## 1-08-15 HBPHAC Dredge Comments and questions for 35% design

## HBPHAC Breakwater Comments and questions for 35% design

01-08-15 HBPHAC Comments and Questions on Docks 35% design

01-08-15 HBPHAC Comments and Questions on Parking lot and Uplands

2.04 sheet- Storm drain not shown for ditch

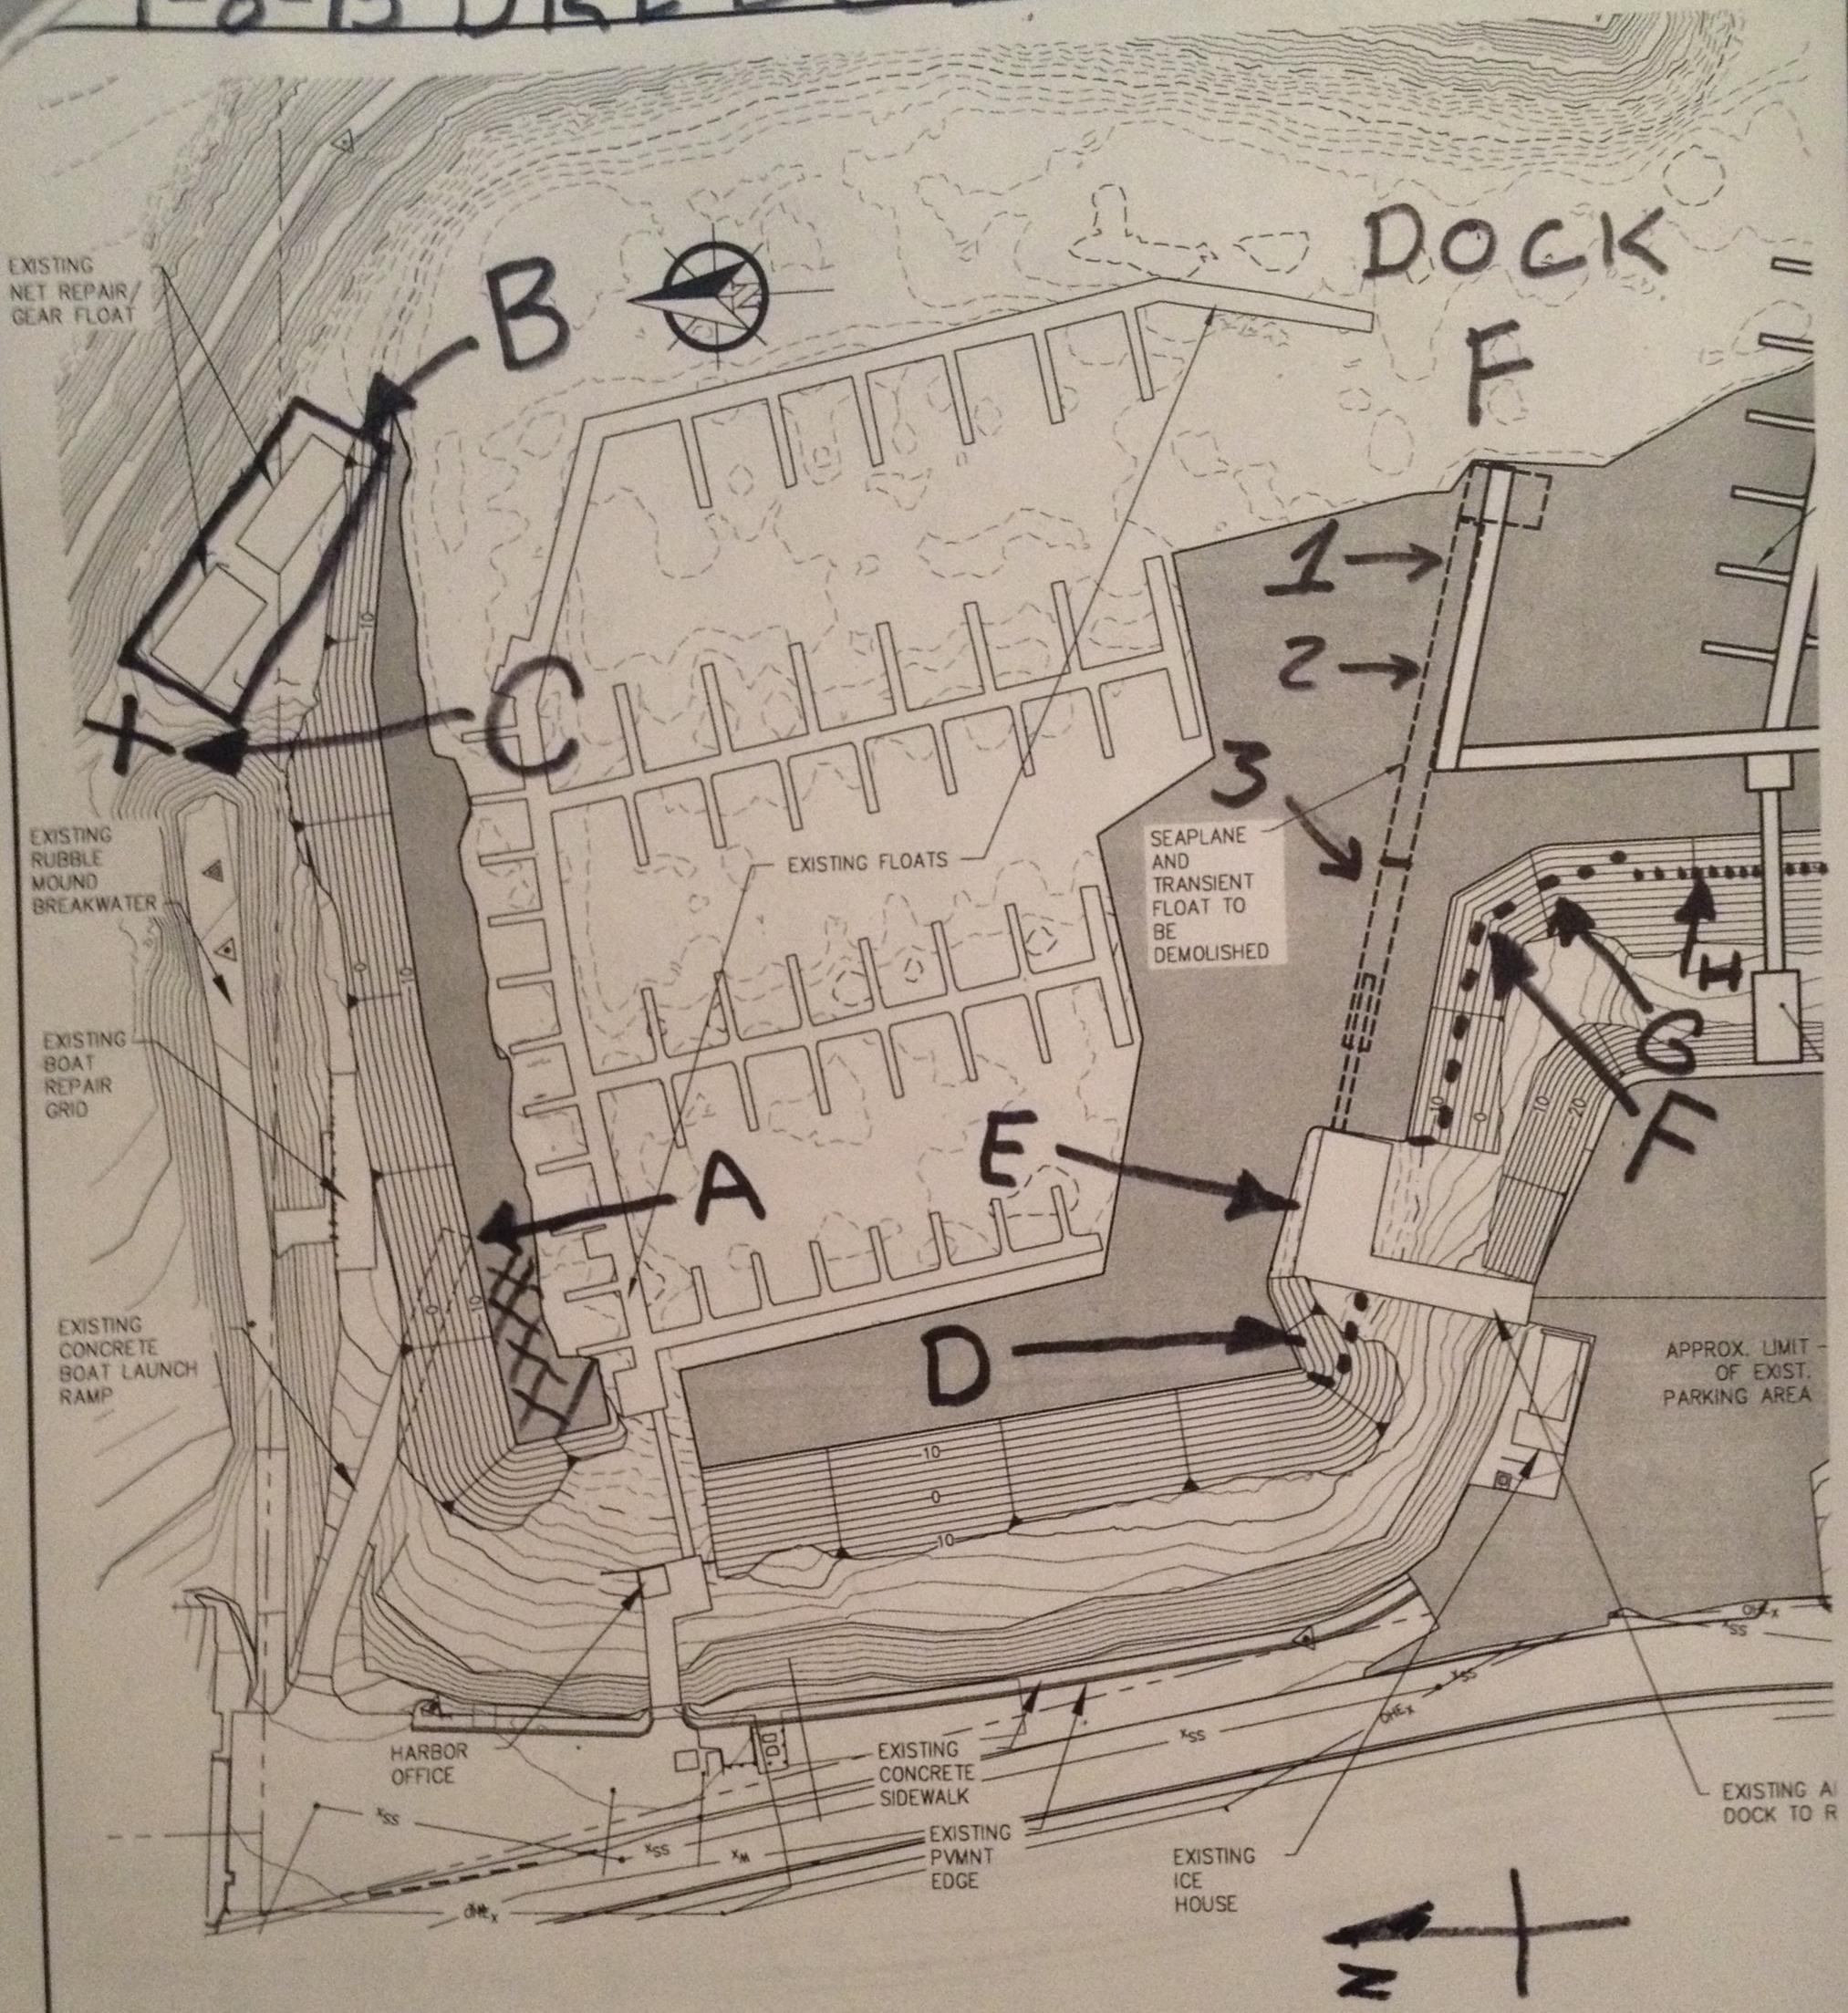
Truck trailer overall length can reach 60 feet.
